HISTORIC AND DESIGN REVIEW COMMISSION

September 20, 2017

HDRC CASE NO: 2017-462
ADDRESS: 228 LAVACA ST
LEGAL DESCRIPTION: NCB 713 BLK 10 LOT E 3.7 OF N 95.1 OF 14, W 9 OF N 91.5 OF 15 & W 45.1 OF E 49.1 OF 15
ZONING: RM-4 H
CITY COUNCIL DIST.: 1
DISTRICT: Lavaca Historic District
APPLICANT: Clint Belew
OWNER: Clint Belew/ SA Rental Group
TYPE OF WORK: Rear Addition; Front Fence; Metal Roof
REQUEST:

228 LAVACA
SAN ANTONIO, TEXAS 78210

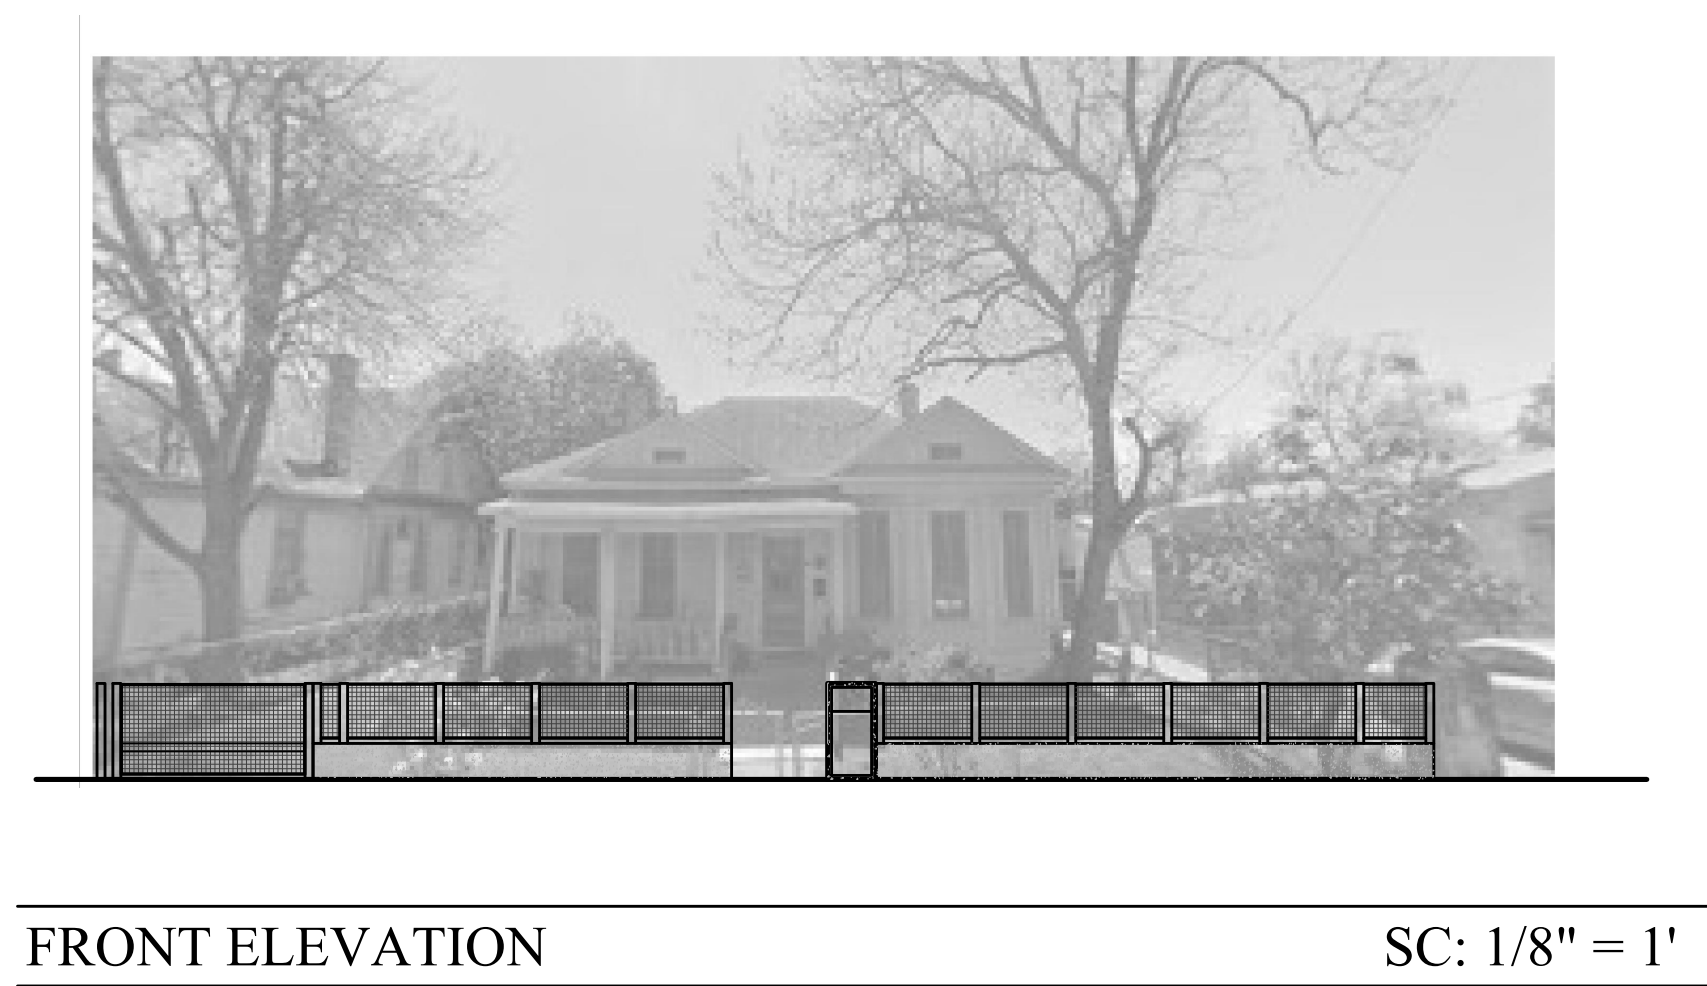
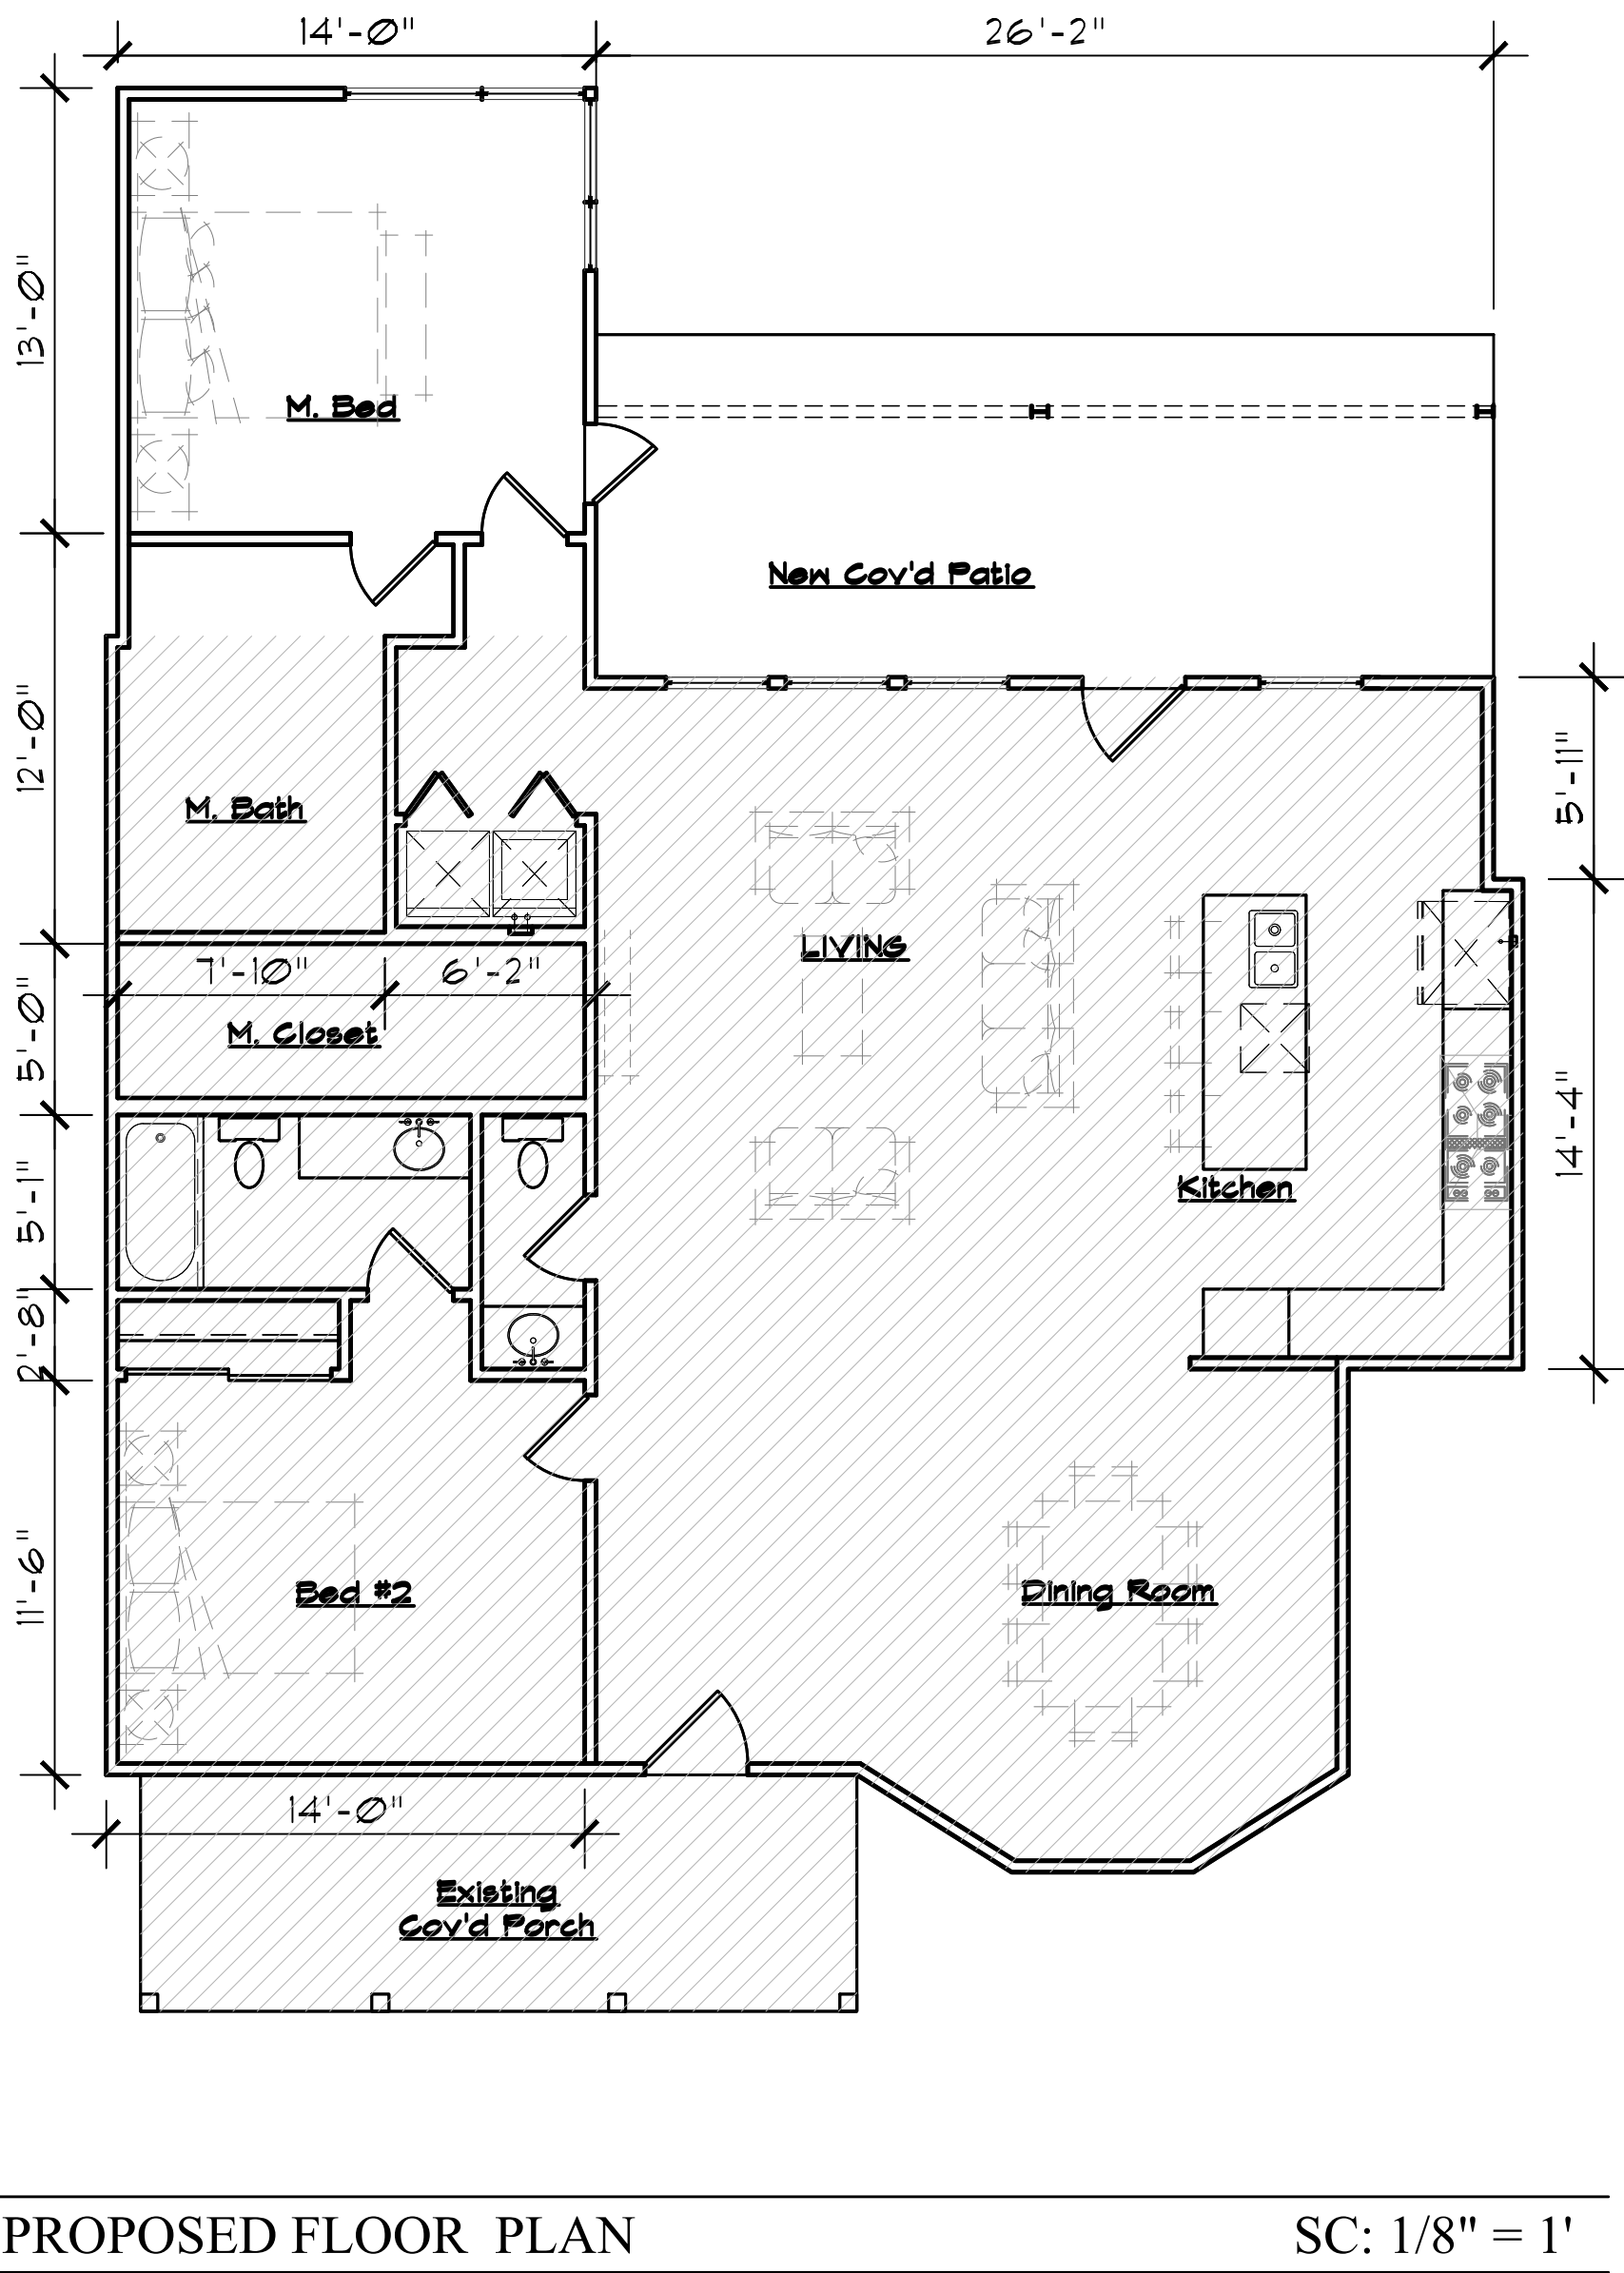
- d. **REAR ADDITION** –At the rear of the primary historic structure, the applicant has proposed to construct a rear addition to feature one story and approximately 400 square feet. The Guidelines for Additions 1.A. states that additions should be sited to minimize visual impact from the public right of way, should be designed to be in keeping with the historic context of the block, should utilize a similar roof form and should feature a transition between the old and the new. The applicant has proposed a rear addition with a flat roof, insets on the both facades from the wall planes of the historic structure. The proposed flat roof is not consistent with the Guidelines; however, staff finds that the proposed form may be appropriate if reduced in width as to not be greater in width or massing that the roof slopes of the primary historic structure.

- e. **SCALE, MASS AND FORM** – Regarding scale, massing and form, the applicant has proposed an addition that generally features a footprint and height that is appropriate and consistent with the Guidelines. As noted in finding d, the proposed roof form should be altered.

- g. ARCHITECTURAL DETAILS – As noted in finding d, staff does not find the proposed roof form to be appropriate. Additionally, the proposed window openings are not consistent with the Guidelines for Additions 4.A. Staff finds that window openings that are grouped and sized similar to those found historically in the district should be used.

Staff does not recommend approval of item #3, the construction of a rear addition based on finding d. Staff recommends that the proposed roof form should be modified to a form that is subordinate to that of the primary historic structure in regards to an overall height that protrudes into the area of the exiting roof slope. Additionally, staff recommends the following:
